Rezoning Transportation Analysis

Petition Number: 2022-139

Date	Description
1-25-23	First Review (TM)
2-22-23	Second Review (TM)
03-30-23	Third Review (TM)

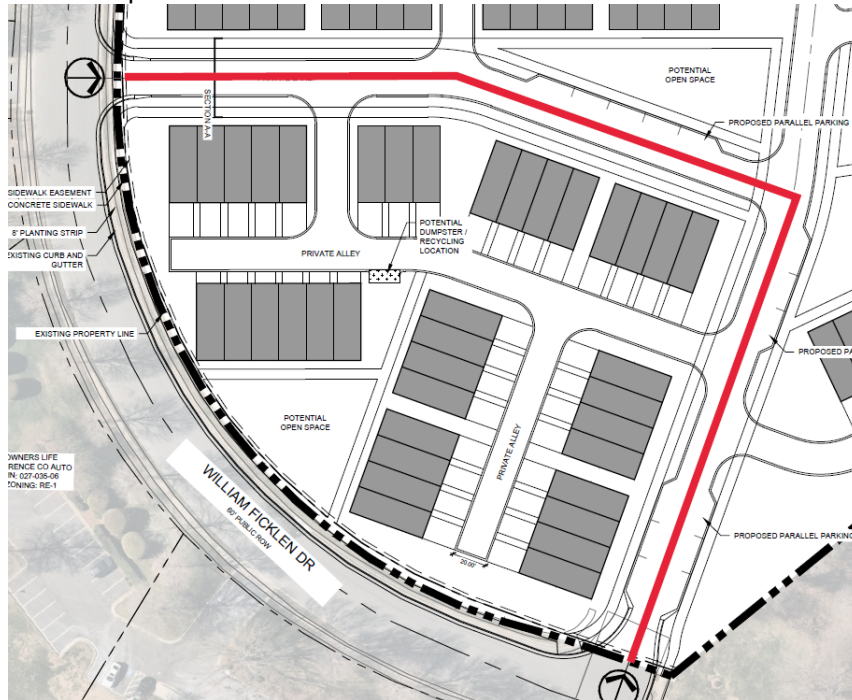
4. **Outstanding Comment from 01-25-23:** Add a conditional note specifying "A Right-of-Way Encroachment Agreement is required for the installation of any non-standard item(s) (irrigation systems, decorative concrete pavement, brick pavers, etc.) within a proposed/existing City-maintained street right-of-way by a private individual, group, business, or homeowner's/business association. An encroachment agreement must be approved by CDOT prior to construction/installation. Contact CDOT for additional information concerning cost, submittal, and liability insurance coverage requirements."

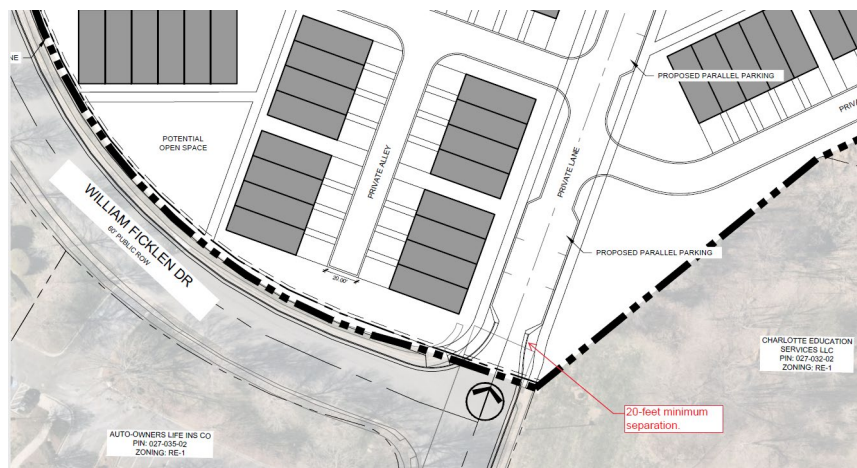
7. ~~Revise conditional note(s) to commit to meeting intersection sight distance requirements. Site entrance locations will be required to meet all ISD requirements.~~
